MR2022022 – SILVER SPRING INTERNATIONAL MIDDLE SCHOOL

NO. MR2022022

MCPB
Item No. 5
9-8-2022

Figure 3: Mandatory Referral Site Plan

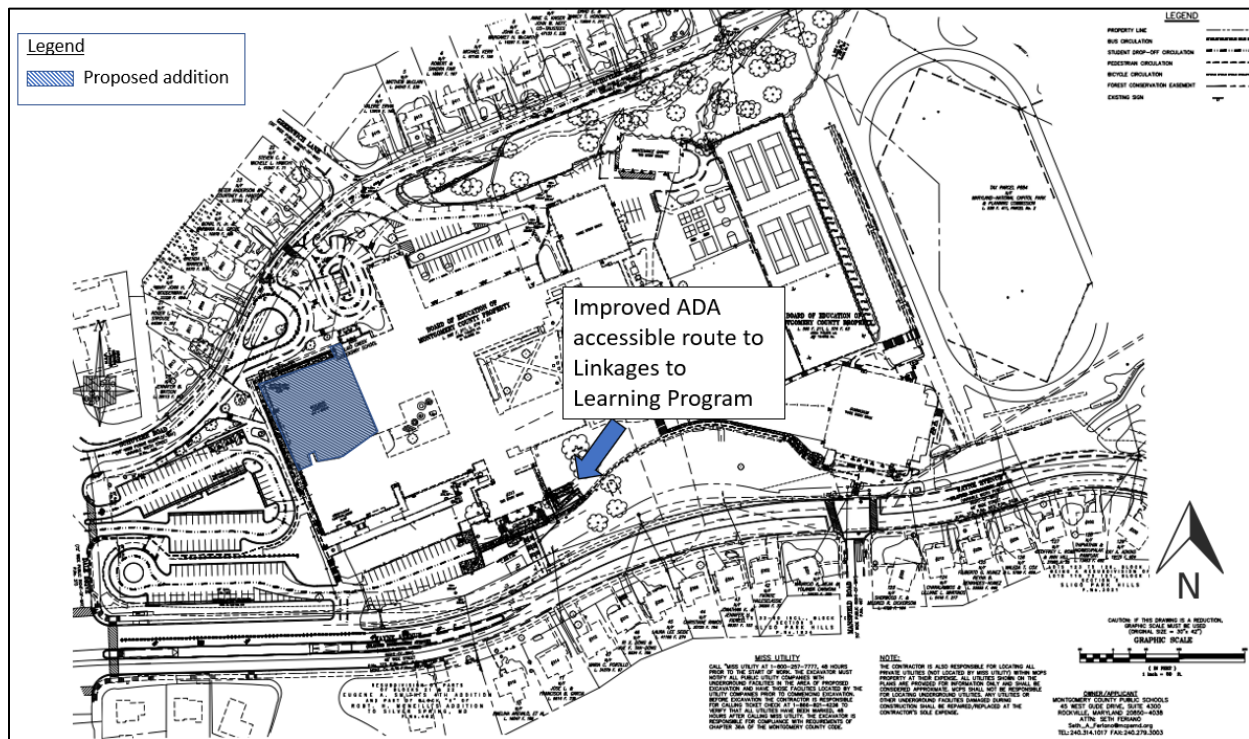
1. Pedestrian Safety
 - a. The Applicant should ensure ADA accessible sidewalks on-site that are a minimum of five feet wide.
 - b. The Applicant should continue to coordinate with MCDOT as they finalize the design and begin construction on the master-planned sidepath along the Dale Drive frontage.
 - c. The Applicant should continue to coordinate MTA on the sidepath improvements planned on Site's Wayne Avenue frontage, in support of the Purple Line.

2. Bicycle Facilities
 - a. Bicycle Parking: The Applicant should provide 60 short-term bicycle spaces (one rack per 20 students) near the main entrances to the building in accordance with the 2020 *Bicycle Parking Guidelines*.
